D2.1 DISCUSSIONS CARRYING OVER; HOST OUTPUT SWING/PEAK

BETH KOCHUPARAMBIL, EMPLOYED BY AND AFFILIATED WITH CISCO SYSTEMS
&
ADEE RAN, EMPLOYED BY AND AFFILIATED WITH CISCO SYSTEMS

SEPTEMBER 22, 2021

Host output differential voltage

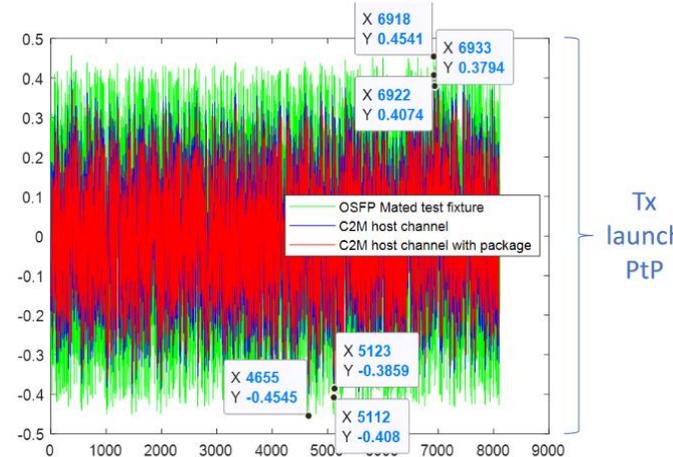
Channel	min/max with PRBS13Q [mV]	% of true PtP	True PtP if 900 mV is measured [mV]
C2M Host channel	-408, +407	84%	1042
C2M Host channel +COM 31 mm pkg	-386, +386	79%	1100
OSFP Mated Test Fixture	-455, +458	93%	957

Measurement with PRBS13Q is much lower than the launch PtP and is channel dependent. With scrambled data the signal can reach the launch voltage. The dynamic range that the receiver will need to handle can't be deduced from the measurement.

The issue was acknowledged but there was no consensus for the proposed change (measure with PRBS31Q)

Concerns were raised about practicality of measurement with PRBS31Q. (all other C2M specs are measured with PRBS13Q).
